COMPANY NAME	Oceana Gold (New Zealand) Ltd
ATTENTION	Dean Fergusson
SUBJECT	MPIV Water Management Technical Documents Review Summary

Brett Sinclair of Wallbridge Gilbert Aztec (WGA) has provided technical peer review services to OceanaGold covering the hydrological and hydrogeological reports submitted in support of the application for consents authorising the MPIV Project.

Figure 1. Mare Burn catchment water quality monitoring points (GHD 2024a).

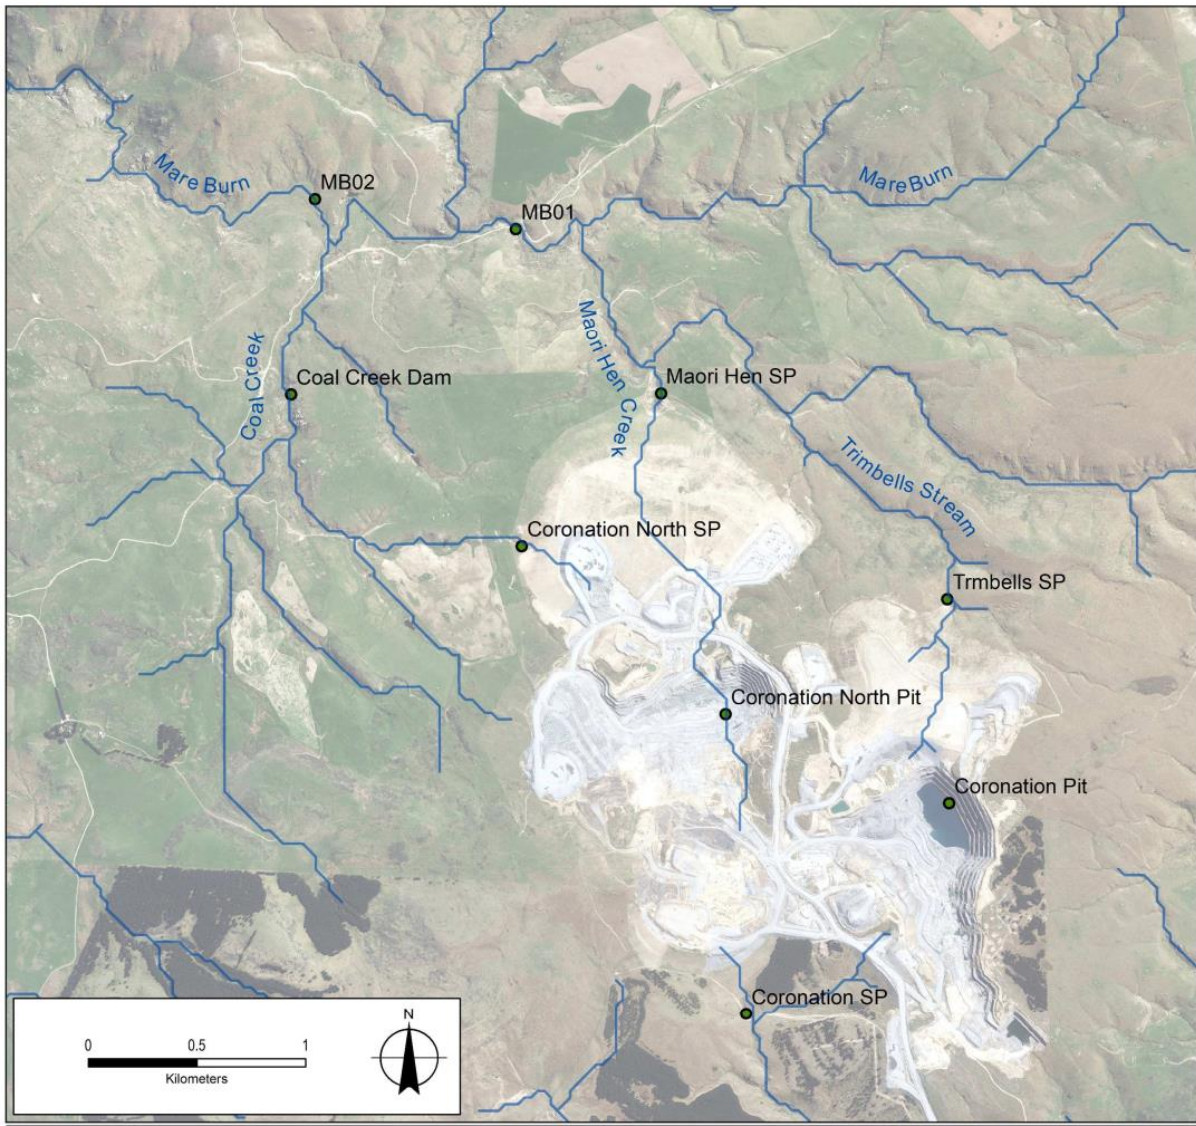
The modelled exceedance curves for sulfate, nitrate-N, and ammoniacal-N at the existing water quality compliance monitoring points MB01 and MB02 appear reasonable. These exceedance curves are consistent with the concentrations of these contaminants applied as input parameters to the model and the availability of dilution water in the receiving streams. The contaminant exceedance frequencies documented in Table 5.7 of the GHD (2024a) report also appear reasonable.

The modelled <1% probability of exceedance for sulfate at both MB01 and MB02 following mine closure is dependent on the buffer storage capacity of both Trimbells Silt Pond and Maori Hen Silt Pond being retained indefinitely. If either or both of these silt ponds are removed, the sulfate exceedance frequency is likely to increase.

Figure 2. Golden Bar Creek catchment water quality monitoring points (GHD 2024b).

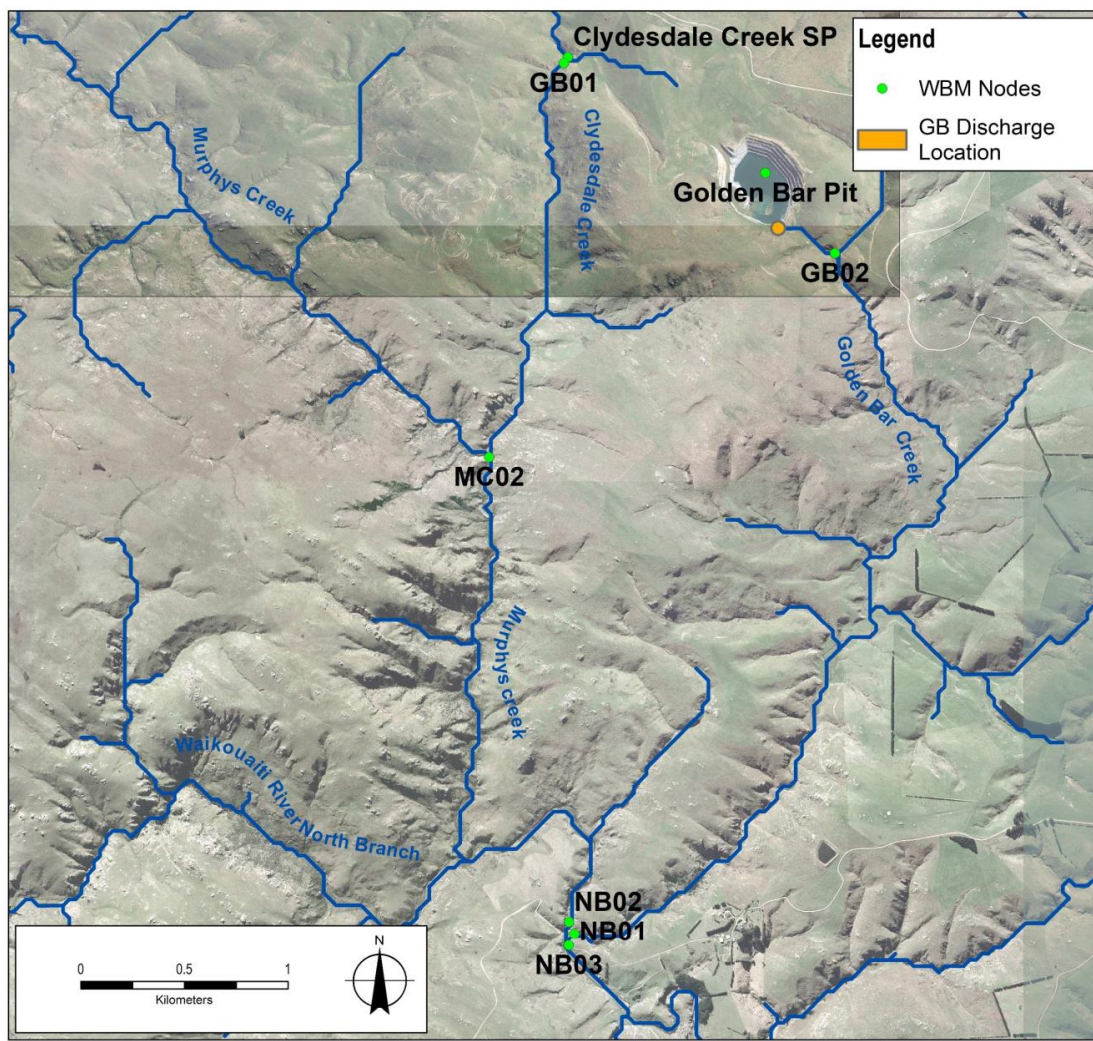
A comparison in modelled and observed sulfate concentrations at NB01 (Figure 2) and NB03 has also been presented to support the model calibration documentation (GHD 2023, Figure 4). This chart indicates the frequency at which sulfate concentrations above approximately 100 g/m³ are generated by the calibrated WBM model is substantially higher than the observed frequency.

Exceedance probability curves for sulfate, nitrate-N and ammoniacal-N at GB01, GB02, NB01 and NB03 (Figure 2) are presented in the GHD (2024b) report. A check has been made comparing the chart outputs against the model input concentrations documented in the GHD (2024b) and MWM (2024) reports.

Figure 5. Water quality monitoring and compliance locations for the MGP (GHD 2024c).

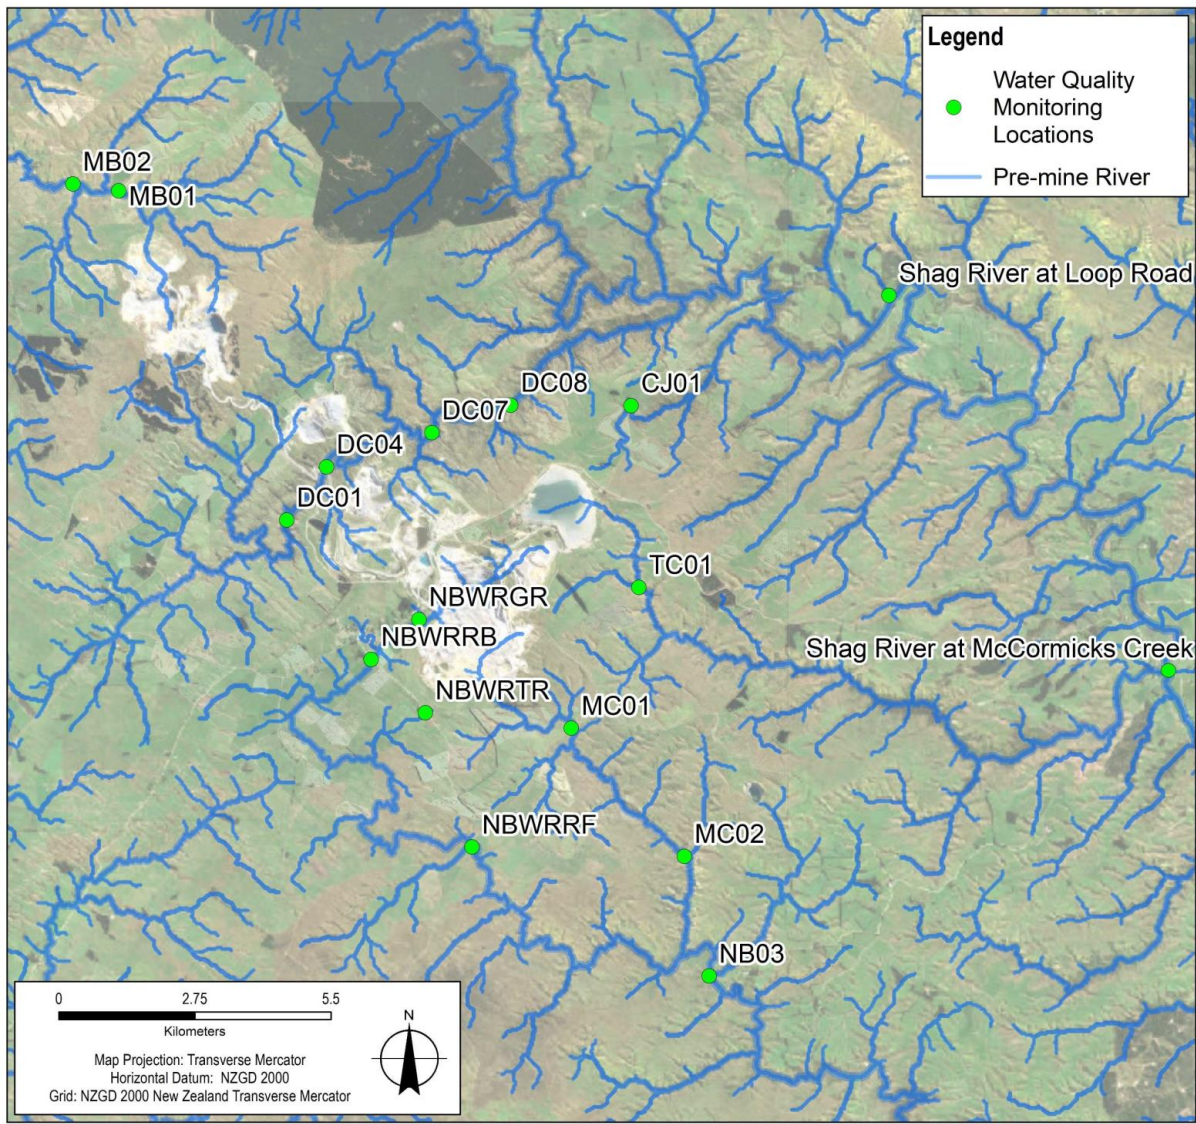
The simulated sulfate discharge areas for these plumes are all upstream from the water quality compliance monitoring points on the Shag River at Loop Road and McCormicks Creek, on Tipperary Creek at TC01 and on the NBWR at NB03 (Figure 5). However, the modelling suggests some contaminants transported in groundwater may eventually discharge to Deepdell Creek and Murphys Creek downstream from designated compliance points on these water bodies (DC08 and MC01, respectively).

Water quality modelling results are presented in the report for the NBWR at the Ross Ford (NBWRRF) and NB03 compliance monitoring points, and for the MC02 compliance monitoring point on Murphys Creek (Figure 5). Model outcomes for compliance monitoring points related to the GB Stage 2 development have been reviewed in Appendix B of this memorandum and are not affected by the MPIV model outcomes.
